1 Products affected

Product hierarchy no.				Part no.	SBU	Product Type
SBU	PG	PUG	Type			
01	002	012	0000000538	0031.2500	Circuit Protection	FUP Fuseholder w/o fuse carrier
				0031.2510		FUP Fuseholder 5x20
				0031.2520		FUP Fuseholder 6.3x32

Product Change Notification					PCN FUP Change of material		
owner	creation date	release date	released by	change order	rev	page	D10-078-720
lutzjo	25.09.2023	24.11.2023	schulejo		A	1 of 2

Current plastic material	New plastic material
Thermoset	Thermoplastic
Current product appearance	New product appearance
ISO view	ISO view

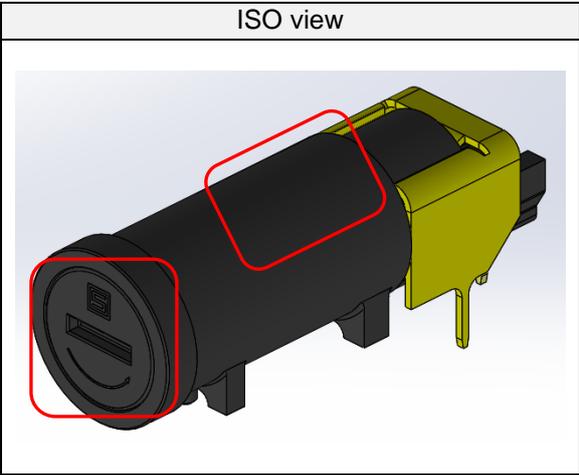
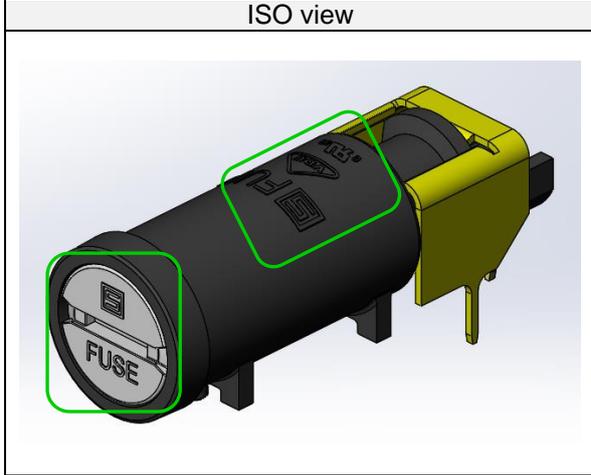
- Change of material
- Change of product design

- New product design
- Position of product marking changed

- Replace plastic material thermoset with thermoplastic for a more reliable moulding process
- Change to a modern design

- Form No action required. Consider new design at incoming inspection.
- Fit No action required. The combination of sockets and carriers of current and new materials is permissible.
- Function
- Manufacturing
- Label
- Packaging
